30th January 2017

Subject: Grenfell Tower installation of new main gas pipe work.

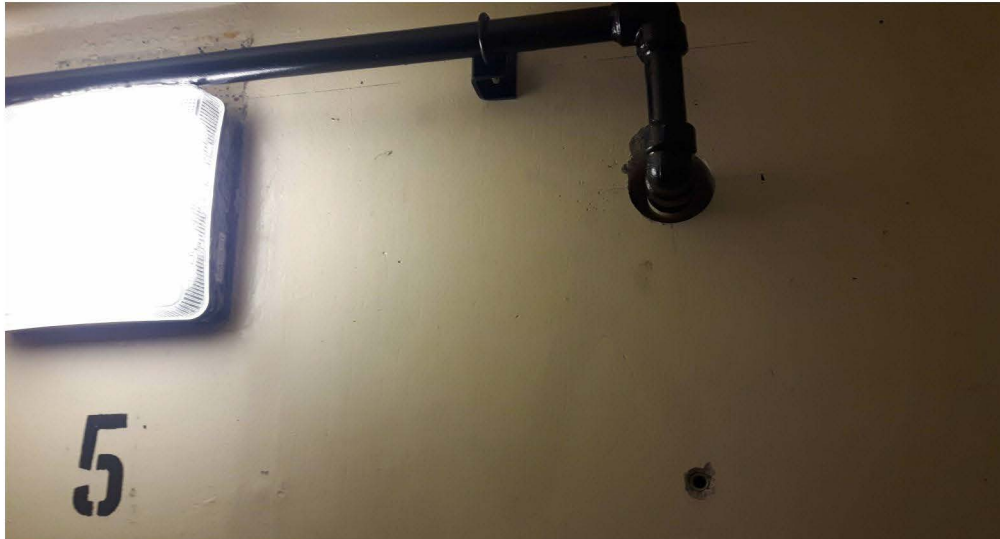
Where the gas pipe penetrates the staircase compartment wall at each floor level there are presently gaps around the pipe, the hole has not been made good. This can be seen in the next 2 photographs.

Gas pipe passing through the staircase to lift lobby area compartment wall, no fire collar has been fitted and the hole has not been made good.

1. As structural work is being undertaken within this building as part of this project has a Building Regulations application been made for the work/project?
2. All holes in compartment wall must be suitably fire stopped using fire rated materials of a minimum of 90 minutes fire rating.
3. Documentation should be provided by the gas contractor showing the fire rated materials used for the fire stopping of the compartment walls and the fire rating of the fire collars used.
